UNITED STATES PATENT AND TRADEMARK OFFICE

APPLICATION NO.	FILING DATE	FIRST NAMED INVENTOR	ATTORNEY DOCKET NO.	CONFIRMATION NO.
10/041,613	01/10/2002	Kwan Yeul Cho	0630-1403P	5085
2292	7590	02/18/2004	EXAMINER	
BIRCH STEWART KOLASCH & BIRCH PO BOX 747 FALLS CHURCH, VA 22040-0747			NGUYEN, HANH N	
			ART UNIT	PAPER NUMBER
			2834

Office Action Summary

DETAILED ACTION

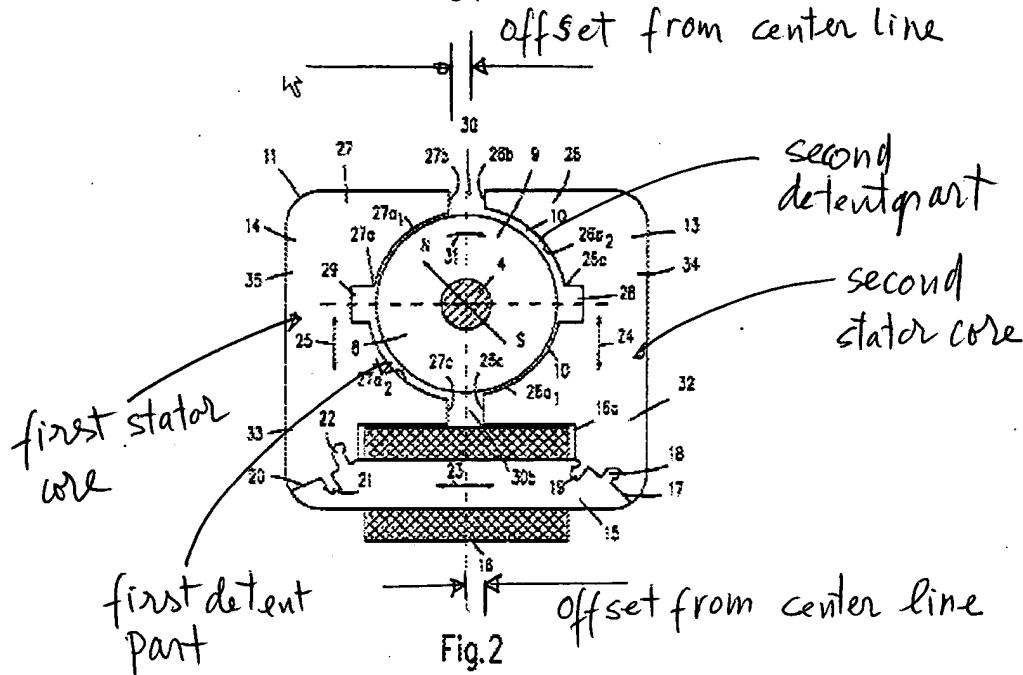
2. Claims 29 and 35 are rejected under 35 U.S.C. 102(b) as being anticipated by Ackermann et al.

Regarding claim 29, Ackermann et al. disclose a skeleton type brushless motor (preamble, patentable weight not given) comprising: a rotor (9 in Fig. 2) having a rotational shaft (4) in a center thereof; and a first stator core (27) having a first rotor receiving part (27a1) formed therein for receiving the rotor; a second stator core (32) having a second rotor receiving part (26a1) formed therein for receiving the rotor; first and second separate spaces formed between the first and second stator cores, respectively; a coil winding unit (15) connected to the first and second stator cores; and a coil (16) wound on the coil winding unit; wherein one end of the first rotor receiving part near the first separate space (27b) and an opposite end of the second rotor receiving part (26c) near the second separate space are offset from a vertical center line of the motor respectively (see markups in Fig. 2).
